SPECIAL AIRWORTHINESS INFORMATION BULLETIN

CE-05-85
September 20, 2005

No. 301/23 issue 2

- Subject** : Lower mounting of the rudder
- Effectivity** : DG-100, DG-200, DG-300, DG-400, all models and all ser.no.'s
DG-500, DG-500M all models up to 5E23
DG-600, DG-600M all models and all ser.no.'s.

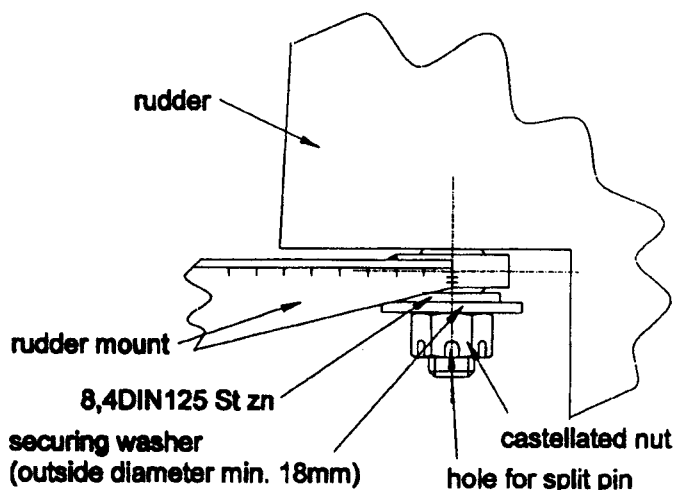
- Instructions**
1. Check if the outer bearing ring is correctly in place in the rudder mounting, the ring should not be visible.
 2. If the bearing is out of place the rudder mounting must be removed and the bearing must be secured by peening with a chisel or the complete rudder mounting must be exchanged. In addition execute instruction 3 at the same time.

3. Check if a securing washer (min. outside diameter 18mm, 0.71 inch) is installed according to the sketch.
 - a) If yes: The execution of this TN can be entered in the aircraft logs by a licensed inspector without further work to be done.

- b) If no: Remove the castellated nut, install the washer 8.4 DIN9021 and reinstall the nut.
 1. Check if the washer is interfering with the rudder mount. If yes, use a washer 6,4DIN9021 St zn instead, enlarge the 6mm hole to 8mm to enable installation.

2. Check if the split pin can be installed. If yes, secure with a new split pin 2x20 DIN94 zn.

If this is not possible, mark the position for a new hole and remove the rudder.
Drill a new hole (diameter 2mm, .08 inch) 90° to the existing hole.
Reinstall the rudder, use new split pins.

Material : 1 washer 8,4 DIN9021 St zn, or 6,4DIN9021 St zn hole enlarged to 8mm
1 split pin 2x20 DIN94 zn
2 split pins 1,5x12 DIN94 zn
If necessary lower rudder mounting:
DG-100, DG-200: L14
DG-300, DG-400: 4L14
DG-500: 5L9
DG-600: 6R14
